29/7-95A John McDonald House

HPC Case # 297-95A

HISTORIC PRESERVATION COMMISSION STAFF REPORT

Address: 10600 River Road Meeting Date: 7/26/95  
Resource: Master Plan Site #29/7 HAWP: Alteration/Addition  
John McDonald House  
Case Number: 29/7-95A Tax Credit: Partial  
Public Notice: 07/12/95 Report Date: 7/19/95  
Applicant: William & Diana Conway Staff: Patricia Parker  
PROPOSAL: Removal & Reconstruction of front porch; Add front gable; alter window & door openings; Construct patio; Alter driveway; Remove trees RECOMMEND: Approval w/ conditions

NORTH ELEVATION

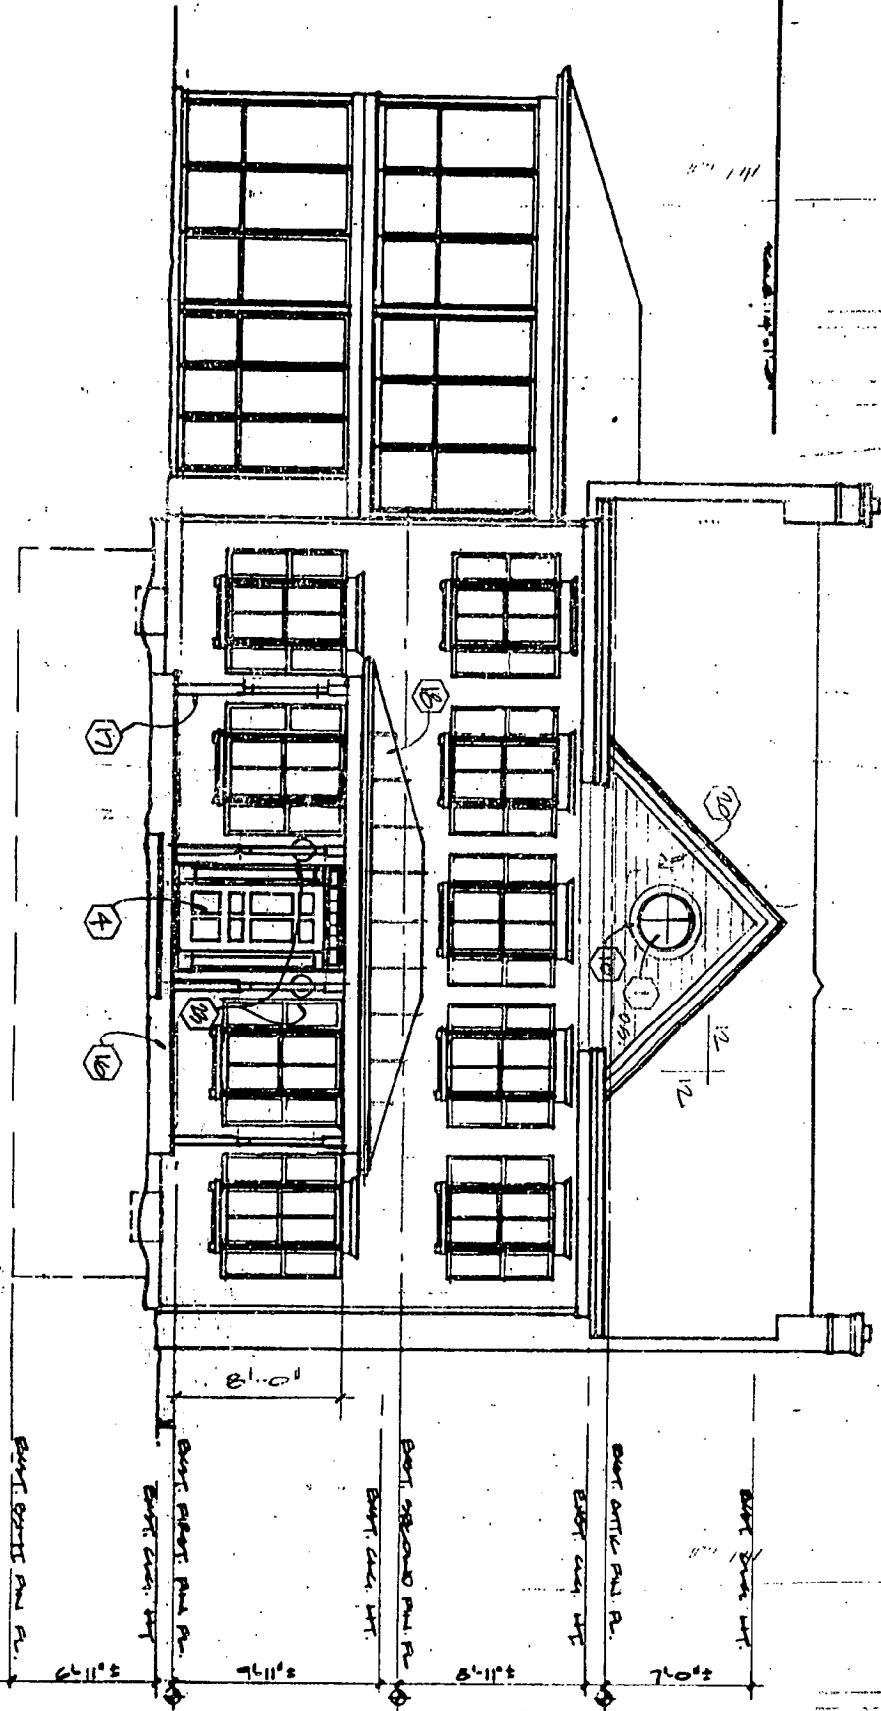
**Principal Facade:** The applicant proposes to remove the existing porch and add a front gable with ocular window. Staff and some Commissioners have visited the site and staff feels that a front gable may have been in existence according to the framing. But staff is concerned about the configured ocular window. Staff has included copies of photos of other resources within the county of this time period (Attached). Ocular windows do appear but they are single pane. Staff would recommend that the applicant revise the window, as proposed, to be single pane.

Photos of other resources also indicate the presence of three bay and five bay porches. But these porches do not have turned posts. Staff feels that the presence of turned posts would not be consistent with this historic house, but would appear on houses of the Queen Anne period. Also, this feature would appear as part of a balustrade (including a rail with pickets) in houses of the later period. Staff would recommend that a simpler post with small capital be used for this porch. Illustrations of post profiles are included as part of this report.

1. Porch posts shall have a straight profile with simple capital.

2. The new ocular window in the new front gable shall be single pane.
